PARKING & TRAFFIC
CONSULTANTS

Australian Turf Club

Proposed Light Rail Project
Assessment of Access and Development Implications

December 2013

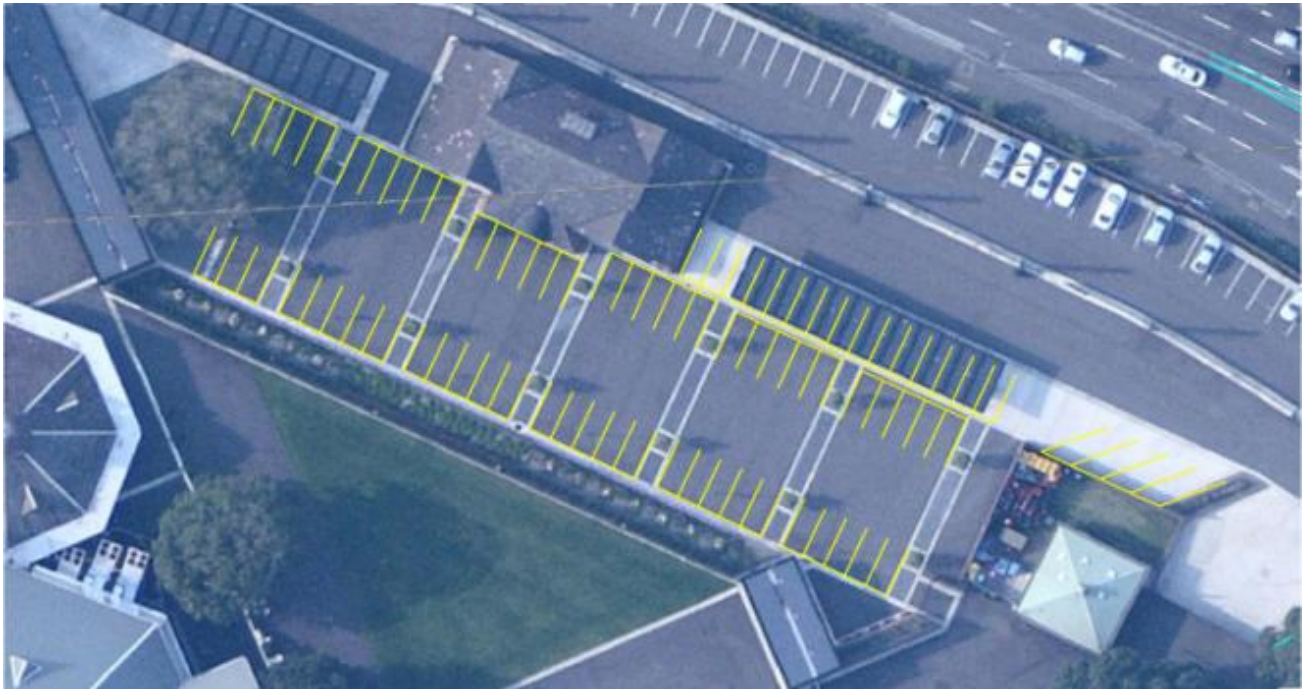
According to the section drawings, the station will be situated at the level of Alison Road, which is up to a metre lower than the current busway level. This will require extensive excavation and the drawings do not indicate how the proposed levels will tie into the existing levels towards the SWAB Building.

This is an important consideration in the context of parking within the Racecourse. The proposed station will remove the existing parking (47 spaces) located within the busway, which is in use for the majority of the time. A further 103 parking spaces is also providing around the SWAB Building as shown in the second image below. With the excavation and levelling works required, it is not clear whether this parking will be replaced.

In this regard the removal of the busway has not been adequately addressed. The current plan to relocate the buses to Lane 1 of Alison Road will be a backward step in terms of the pre-busway arrangement, with the added complication of a busy and active light rail line between the Racecourse and the buses.
